BSIS

Clarification on long TTCs, temporary sensor blockage and calibration

Two scenarios

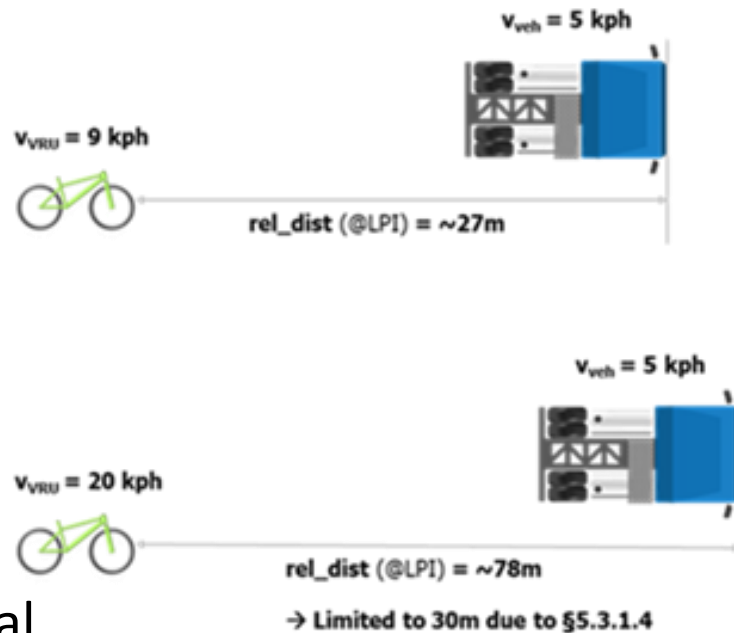
rel_dist (@LPI) = ~27m
 Delta_v = 4 kph
 TTC = ~24 s 
 Real life use cases?

Technically possible but **behaviour is not understandable / easily verifiable for the driver.**

Long information time for slow VRU.
vs.
 Short information time for fast VRU.

rel_dist (@LPI) = 30m
 Delta_v = 15 kph
 TTC = ~7 s

In conflict with § 5.4.1 / § 5.5.2, which request a system that is easy to understand.

Similar to limitation of the FoV (30m to the rear and 7m to the front) we propose to limit the TTC. The value must be decided within the VRU Proxy group. Example: “Information signal shall be provided, at least, when a potential collision with cyclist is less than [X] TTC”
